Memo

From: MN DNR

RE: JD3 Model Review

The purpose of this memorandum is to summarize the review findings of the ISG Inc.'s XPSWMM model of the Jackson County Judicial Ditch No. 3 (JD3) system. A proposed project to modify JD3 system is under review by the Minnesota Department of Natural Resources (DNR) and the Heron Lake Watershed District Drainage Authority.

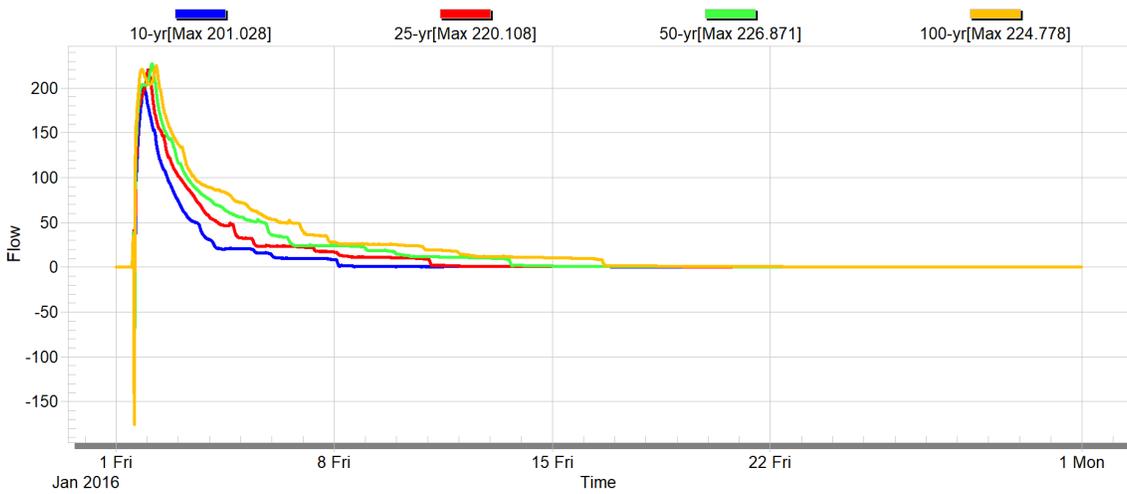
Comment #2: Table E21 in the output file, summarizes the continuity balance at the end of the simulation. This is a measure of the total system inflow minus the total system outflow. The total continuity error in the existing model “17285 (193) Existing – Heron Lake update_100-yr.out” file is 22.0% and in the proposed model “17285 (193) Proposed Heron Lake Outlet Updated_100-yr.out” file of 21.9%. This represents a loss of approximately $1.09E+09$ ft³ of water in both models due to continuity error and model instability. According to Table E18, this is considered “Poor” Continuity. Both models should be edited to be run with a “Good” total continuity error shown in Table E21 of less than 2%.

Conduit 4934.1 from Node3109 to Node22

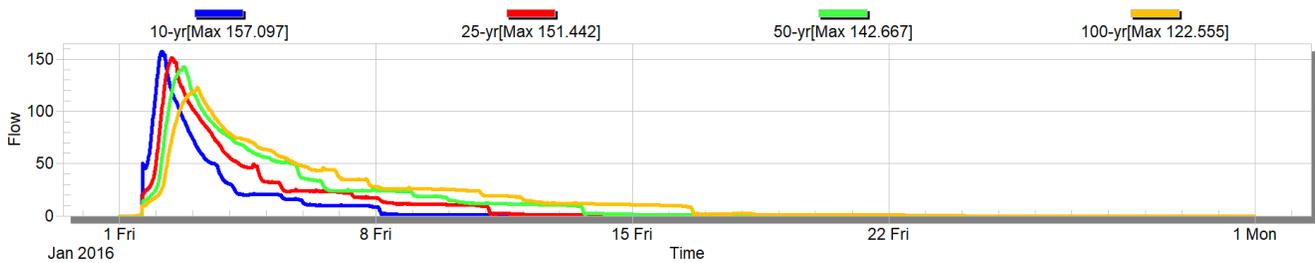
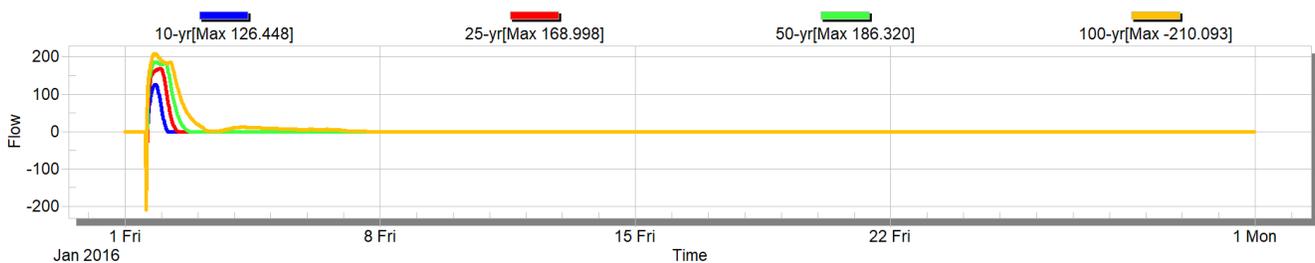
Comment #5: The “constructed wetland” at Station 5+00 of Branch H adjacent to 400th Ave is modeled as a series of natural channel links with storage included within the custom natural section shape. The results for the peak flows through Link21 and Link 4934.1 show the peak flow through the “wetland” and at the 54-in RCP outlet decreasing with higher storm events (i.e., for Link21 100-yr peak is 224.778 cfs and 50-yr peak is 226.871 cfs). Please provide an explanation for this modeling result (see figures next page).

Conduit Link2192#t from Node2663 to Node2664

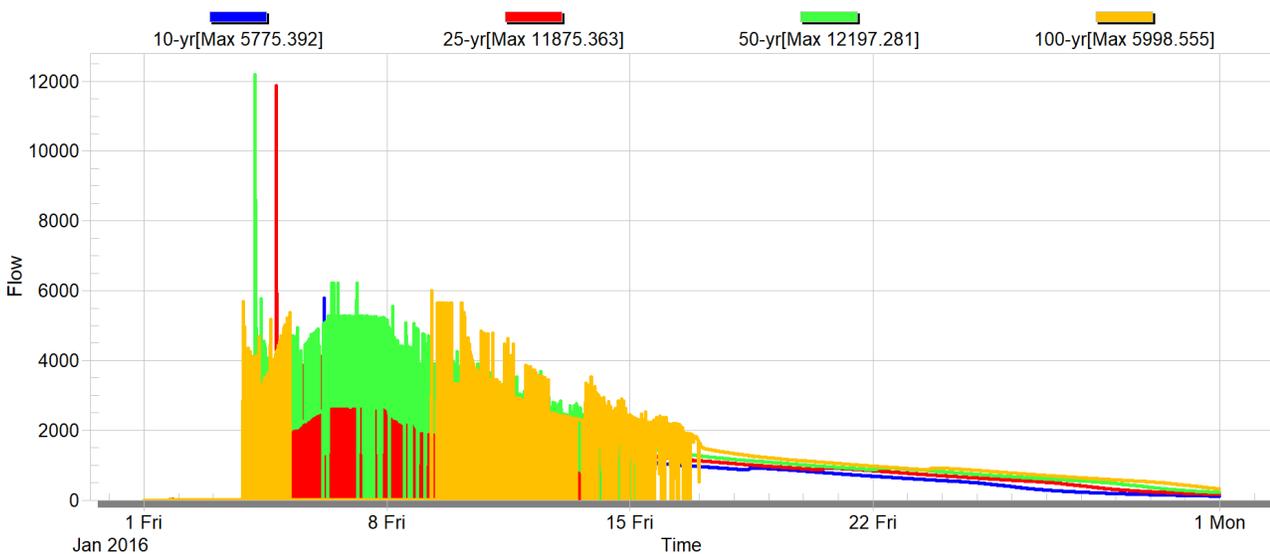
Comment #9: Link 2192 representing a bridge downstream of North Heron Lake appears to have an instable solution. The model should be modified to show a more stable solution in this link to ensure accurate model results.
